**Twickenham Riverside  
 Response to Additional Comments – Highways and Transport Response**

This letter seeks to provide a response to additional transport and highways queries received from officers via email dated 23 and 24 March 2022. This email seeks clarification on all matters raised. These responses should be reviewed prior to the technical workshop session scheduled for Monday 25 April 2022.

**Appendix 1**

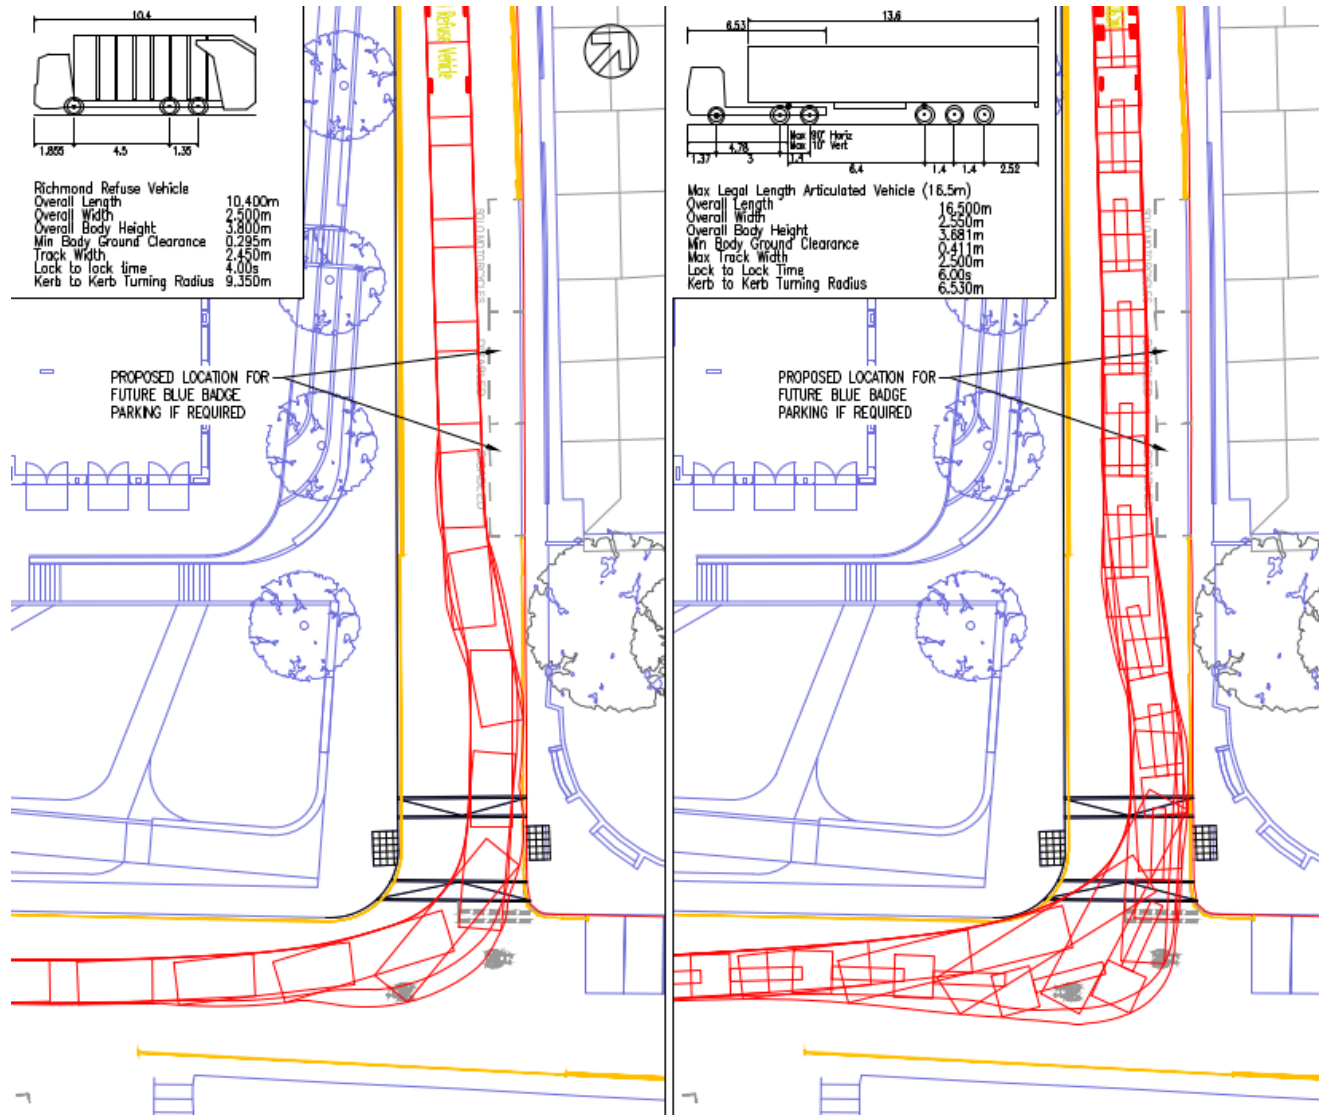
Whilst these have not been indicated on the General Arrangement scheme drawings (given there is no requirement nor need to implement these bays from the point of first operation), the location for two additional bays has been considered through Stage 3 and Stage 4 design optioneering. The two bays would be located along Water Lane, south of the service road and Motorcycle Bay, as shown in Appendix 1. The location of the 2 additional accessible bays are considered suitable for the following key reasons:

<ul style="list-style-type: none"> <li>• They are in the location of existing parking bays to the southern end of Water Lane, and therefore do not represent a significant change.</li> <li>• Vehicle swept-path and tracking has been undertaken to illustrate feasibility of manoeuvre along Water Lane to ensure two-way access (including HGV access) can be maintained between the embankment and King Street along Water Lane.</li> </ul>
<p>On Wharf Lane:</p> <ul style="list-style-type: none"> <li>• there remains concern over visibility, particularly of pedestrians travelling along the southern footway along King Street.</li> <li>• Concerns have also been raised regarding the large vehicles turning left out of the junction and needing to get into the nearside lane to travel along Cross Deep encroaching on cyclist and vehicular traffic in the central cycle lane and the outside lane.</li> <li>• Whilst the matter has been discussed in the Road Safety Audits, it is recommended this is addressed now, as when you come to submit a junction design as part of the S278 process, to ensure this is feasible.</li> </ul>	<p>Both points have been responded to thoroughly through the RSA Stage 1 response. With the lower traffic volumes than the existing site, slow speeds on the approach and signalised junction immediately west of Wharf Lane along King Street all mechanisms to facilitate and encourage safe operation of the junction. It is also worth noting that the junction proposals maintains the same level of safety as the current position. We note the recommendation regarding the s278 process.</p>

**Appendix 2**

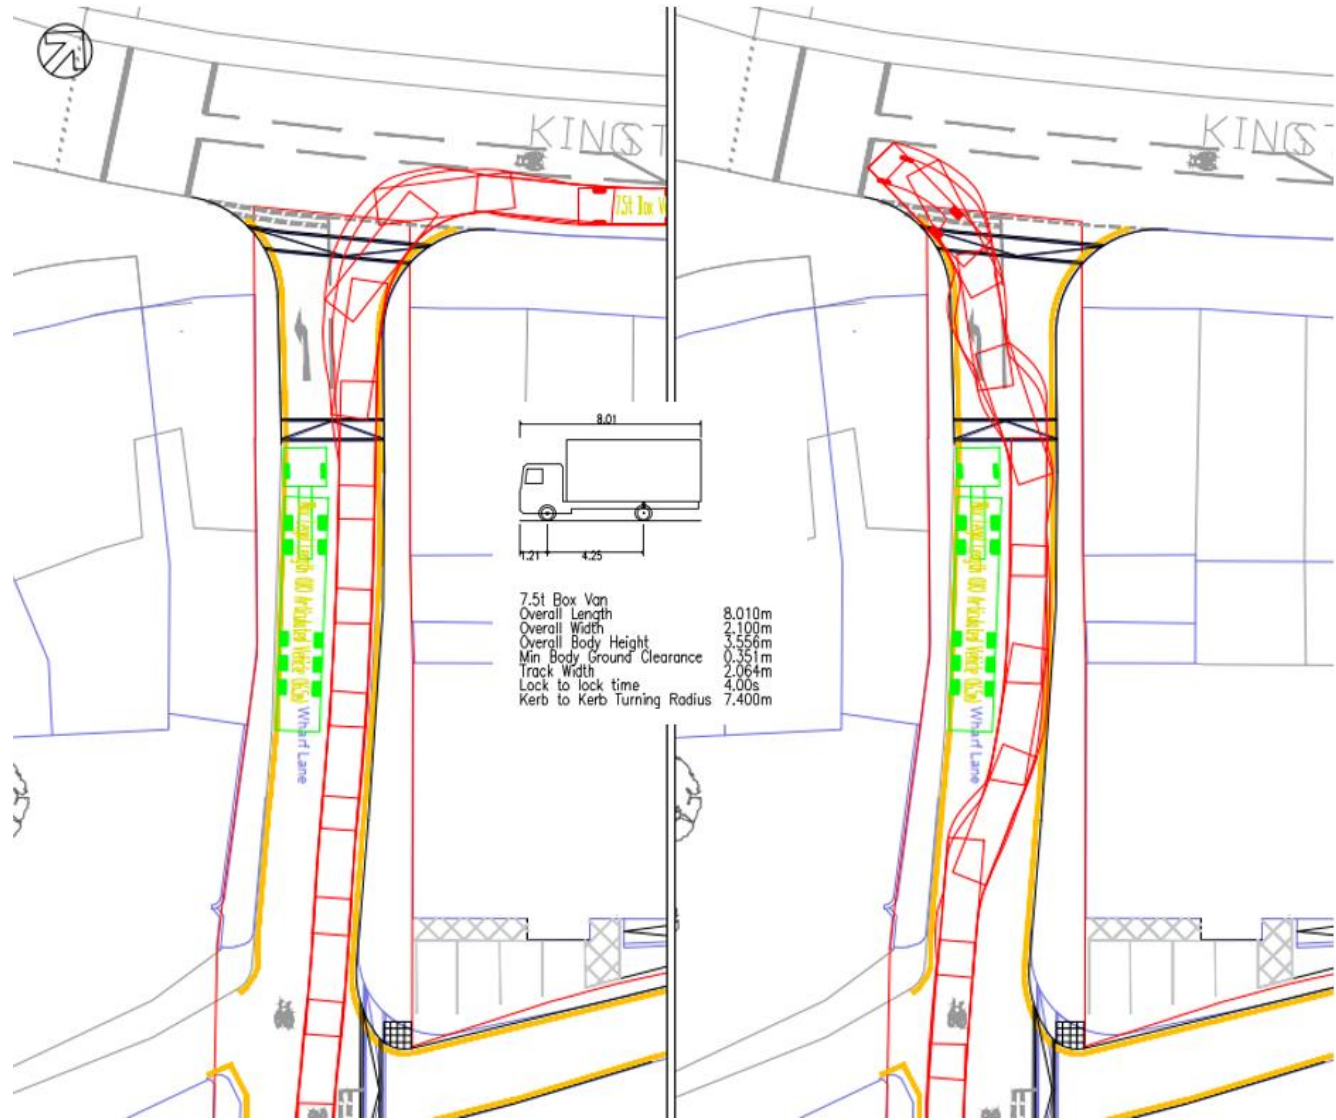
<p>Water Lane</p> <p>a. There is concern over the pinch point between passing traffic and the width of the loading bay – it is recommended the loading bay should be reduced to 2.5m in width to allow a passing space of 2.9m wide or consider relocating the bay further south where the carriageway is wider.</p>	<p>A key reason for implementing another Loading Bay to the north of Water Lane is to help better serve Church Street. To be effective and reduce trundle distance for servicing operatives, it is suggested this location as far north as possible and is retained to serve Church Street effectively.</p> <p>The recommendations on measurements are noted, and we can confirm that the loading bay can be reduced to 2.5m in width to facilitate a passing space of 2.9m.</p>
<p>Water Lane:</p> <p>b. Questions are raised over the appropriateness of disabled parking bay on the eastern side of the carriageway. Water Lane is on a gradient which means a wheelchair user would have to climb a slope. There is no point in proposing a disabled bay that is difficult for disabled motorists to use</p>	<p>Accessible bay locations are ultimately constrained by the site layout. The southern and northern ends of Water Lane, which are currently locations for existing parking, are deemed to be the most appropriate area to locate accessible bay provision within the masterplan layout.</p> <p>Other locations within the site have been reviewed and considered, but are deemed inappropriate for the following reasons:</p> <ul style="list-style-type: none"> <li>• The Embankment is car free, within the flood zone and represents the lowest point of the site in terms of level gradient</li> </ul>

<ul style="list-style-type: none"> <li>• The service road is not wide enough to accommodate additional vehicle parking, one accessible bay is already provided here.</li> <li>• Wharf Lane (south end) would not provide an improved gradient for parking bays or for additional parallel parking bay implementation and commercial servicing bay in this location</li> <li>• Wharf Lane (north end) is Double Yellow Line and will not be used for car parking throughout the day, ensuring articulated vehicle parking in proximity to Iceland in the morning and two-way vehicle access throughout the day</li> <li>• Water Lane (north end) has been prioritised for an additional communal loading bay facility with Church Street further to previous design requests, so potential locations for parking here must be further south along Water Lane</li> </ul>
<p>Water Lane:</p> <p>c. There are inconsistencies between the Highways General Arrangement Drawing and the surfacing and materials plan. The Highways General Arrangement Plan shows a footway width of 1.4m immediately east of the on-carriageway loading bay proposed on the eastern side of Water Lane south of its junction with King Street. The Surfacing and Materials Plan shows almost no footway at this location.</p> <ul style="list-style-type: none"> <li>➤ In the commentary on the Surfacing and Materials Plan it states the scheme will provide a generous pedestrians space along Water Lane - There needs to be a minimum footway width of 1.2m at this point to comply with national highway design guidance set out in Manual for Streets (2007).</li> </ul>	<p>Please see drawing 6975_100 prepared by LDA. This shows that the proposed footway width is clear of approximately 1.6m, wider than the 1.2m minimum width.</p>
